MEMORANDUM

Subject: draft-partial Groundwater Monitoring and Aquifer Compliance Plan (MACP), Dual Site Groundwater Operable Unit Del Amo Superfund Site, Los Angeles, California (draft-partial MACP), prepared by URS, September 5, 2014. And the Draft Groundwater Monitoring and Aquifer Compliance Plan, Montrose Superfund Site, 20201 South Normandie Avenue, Los Angeles California, July 23, 2014

DTSC Cleanup Program Geological Services Unit (GSU) Cypress staff reviewed the Del Amo draft-partial Groundwater Monitoring and Aquifer Compliance Plan (draft-partial MACP) provided by Shell Oil Company on September 5, 2014. The Del Amo draft-partial MACP presents a preliminary sampling/monitoring strategy for monitoring wells Shell Oil Company identified as related to the Del Amo Superfund site benzene plume.

Montrose and Del Amo Site Area with Water Table TI Waiver (Containment Zone)

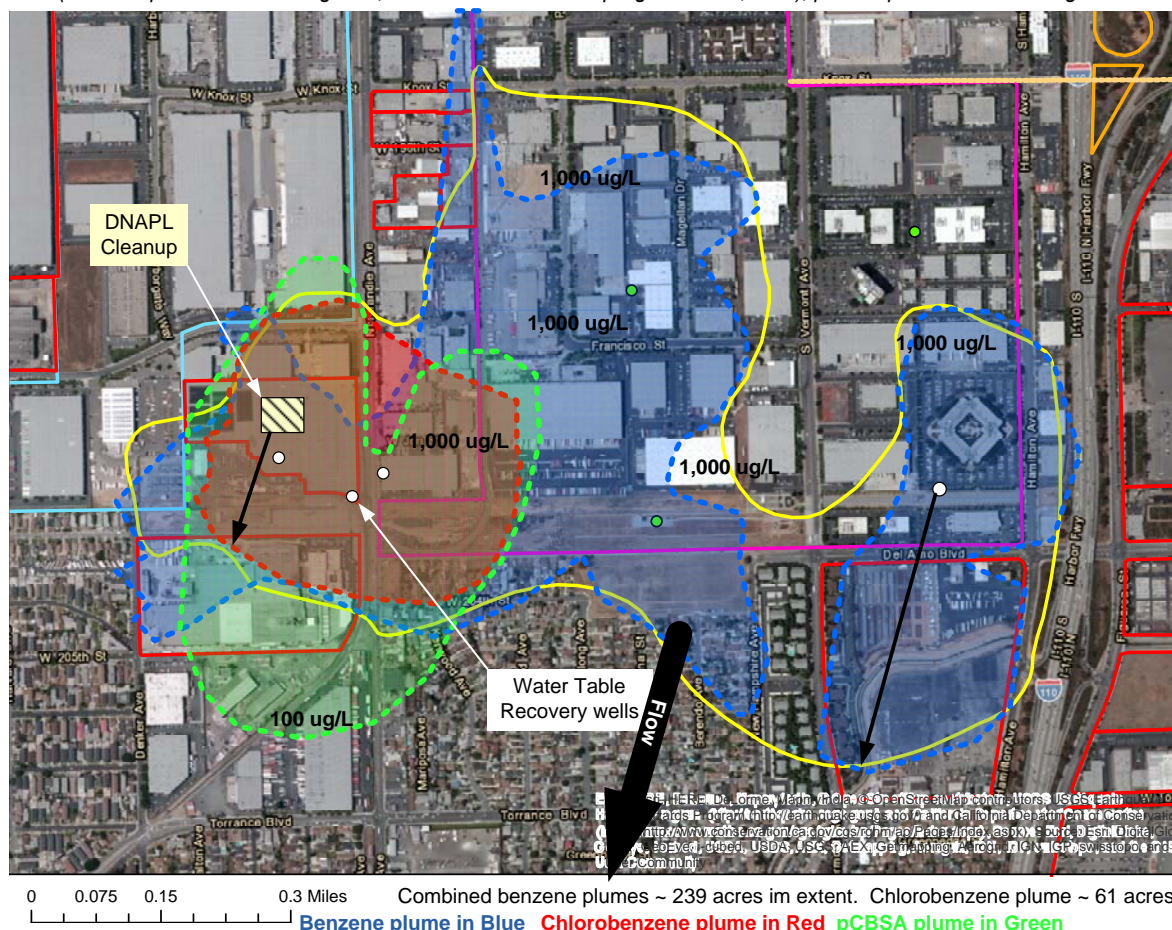
A black line is shown bisecting the benzene and chlorobenzene plumes in the approximate downgradient direction (in the water table). In general, the black line begins in the presumed source area and extends downgradient to plume edge. The line bisecting the benzene plume (blue area) is on the order of 1,750 feet long (in the water table). The line bisecting the chlorobenzene plume (red area) is shown to be approximately 750 feet long. These lines imply that the benzene plume has migrated

approximately twice as far as the chlorobenzene plume migrated in the water table which is contrary to statements in the Groundwater ROD.

The TI Waiver (Containment) Zone is illustrated by a yellow line in the plume figures.

By combining the area of the left and right lobes of the benzene plume in Figure 1 (above), the total area covered by benzene is approximately 239 acres (at the water table surface). The chlorobenzene plume covers approximately 61 acres (at the water table surface).

Figure 2 Illustration of Benzene and Chlorobenzene Plumes 2006 and pCBSA (1990, 1995 and 2012) in MBF B/C Sand

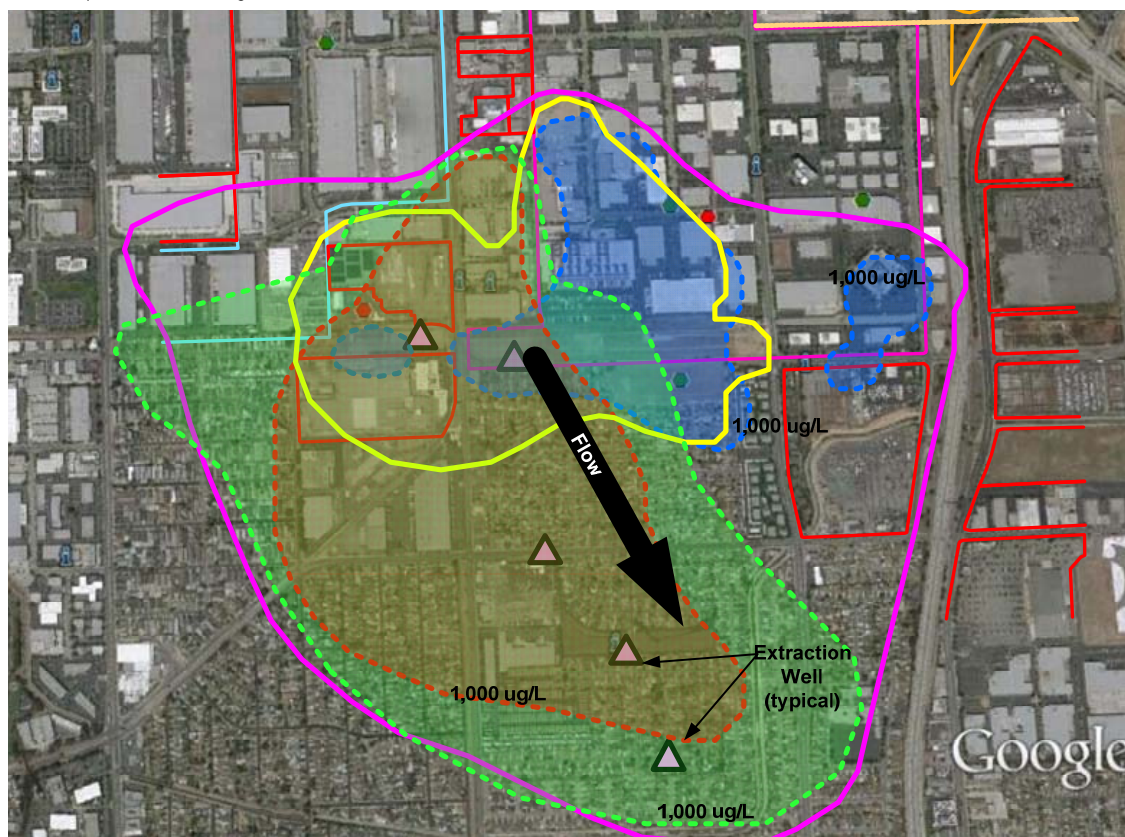
Both plumes extend further from the site in the MBFB/C Sand (see Figure 2 - below) and in the Gage Aquifer (see Figure 3 - next page). However the monochlorobenzene

and pCBSA plumes are elongated along a trend from Montrose, along the Kenwood Drain all the down to the ARMCO site. The elongation is clearly shown on Figure 9 (Chlorobenzene in MBFC) and Figure 10 (pCBSA in MBFC, see Montrose MACP).

Figure 3 Illustration of Benzene and Chlorobenzene Plumes 2006 and pCBSA (1990, 1995 and 2012) in Gage Aquifer

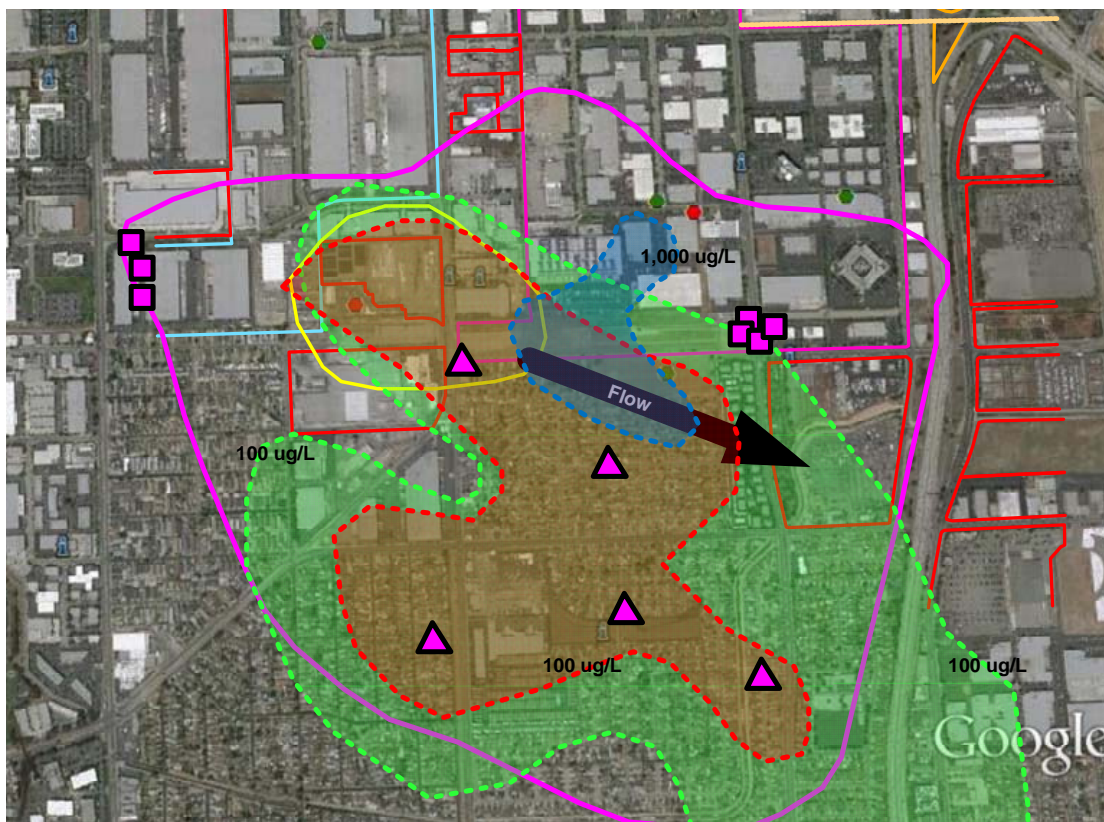
The trend remains apparent in the chlorobenzene and pCBSA plumes in the Gage Aquifer [see Figure 3 above and Figure 11 (Chlorobenzene in Gage Aquifer, Montrose MACP) and Figure 12, (pCBSA in Gage Aquifer, Montrose MACP)] even though the direction of groundwater flow is East-Southeast. It appears likely chlorobenzene and pCBSA infiltrated the soil and migrated to the MBF Sands and the underlying Gage aquifer in sufficient quantities to remain elevated decades after site activities ceased.

Figure 6 Distance Dependent Concentration Gradient Illustration

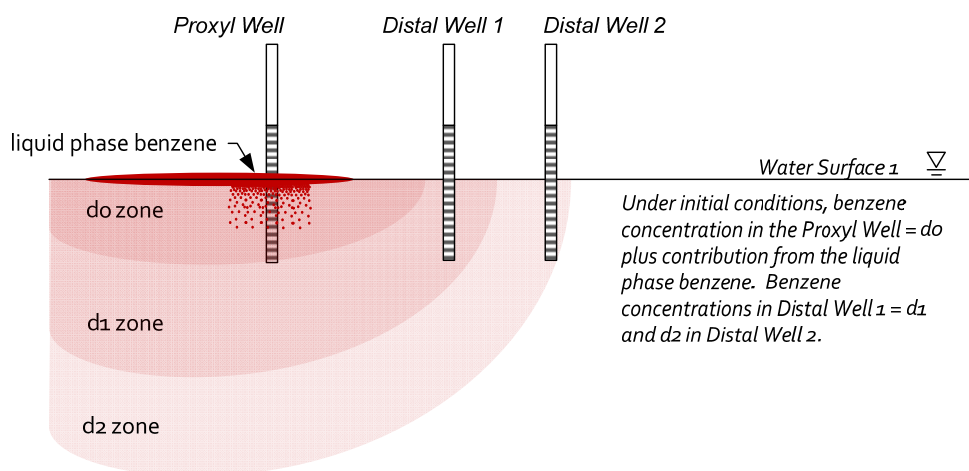
Figure 6 (above) illustrates a series of groundwater wells located in different parts of a benzene plume area and shows how benzene concentrations would be expected to decrease with lateral distance from a continuing source. Figure 6 shows a well design where the monitoring wells are constructed with the screen interval above and below the water surface.

The zones indicated as d_0 zone, d_1 zone and d_2 zone illustrate a concentration gradient where the benzene concentrations decrease as distance from the source material increases. The conditions illustrated here exist within the area of the Dual Site Groundwater Operable Unit.

Figure 7 Depth Dependent Concentration Gradient Illustration

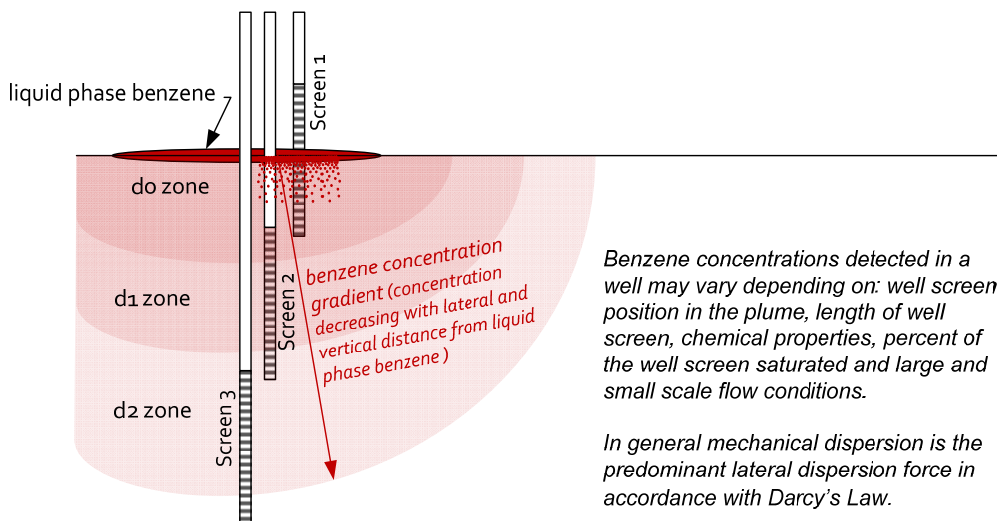
Figure 7 above, illustrates a vertical concentration gradient by showing a series of wells along a vertical profile. Screen 1 is shown as being 50 percent saturated. The submerged portion of the well screen is located within a specific concentration interval (d_0 zone). Screen 2 crosses through d_0 zone, d_1 zone and d_2 zone therefore a sample collected from the top of screen 2 could yield a different result that one collected from the bottom of screen 2. A sample collected from the middle could yield an intermediate concentration and complete well purging could yield another result dependent on which zone provides the greatest flow into the well. Screen 3 is also shown transitioning from D_2 zone to an unidentified zone, which could also return different results depending on sampling location and methodology. Shorter well screens reduce variation.

Figure 8 Interim Conditions Illustration
Illustration of Interim Conditions proxyl to and distal of the liquid phase benzene after 10' water level rise

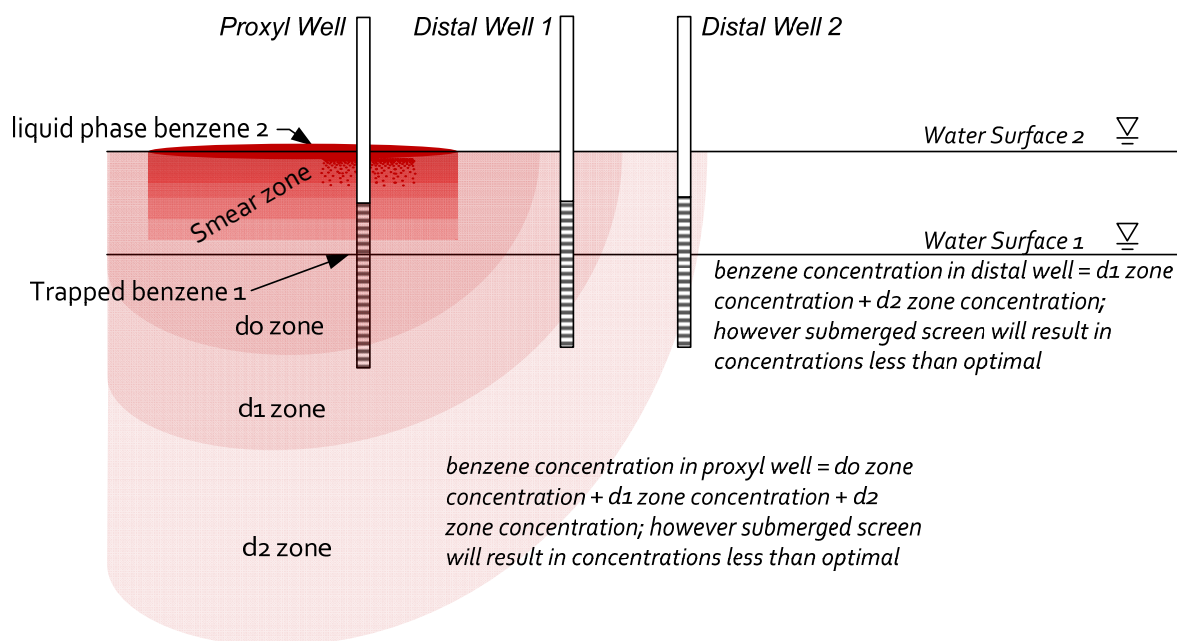
Figure 8 illustrates how LNAPL in the Proximal Well has been cut off and can no longer enter the well. In this case the LNAPL is physically blocked from re-entering the well, which could yield inaccurate plume monitoring information. Comparing monitoring well screen in Figure 6 and Figure 8, it's clear that contaminant concentrations could also appear reduced in distal wells by dilution.

Figure 9 Conceptual Monitoring Well Illustration

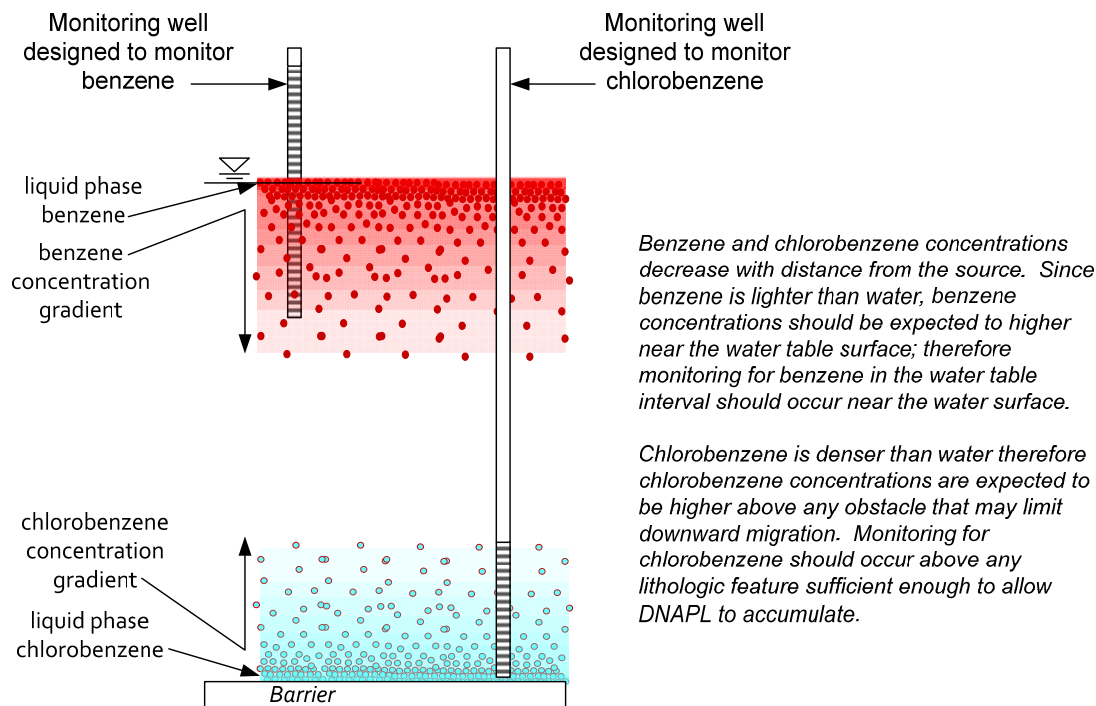
Fundamental Comment Number 7: Light and dense contaminants are likely to act differently in the groundwater due to the density and molecular differences of the contaminants. In this case representative concentrations of light contaminants should be expected to be found in the top of the water column, while the denser contaminants are more likely to be detected in the lower part of the water body.

Therefore monitoring for the presence of light contaminants requires wells screened in the water table and shallower parts of the aquifers while monitoring for the presence of denser contaminants requires well screens located above lithologic features that would impede downward contaminant migration. Figure 9 illustrates that wells need to be specifically designed to monitor the different classes of contaminants.
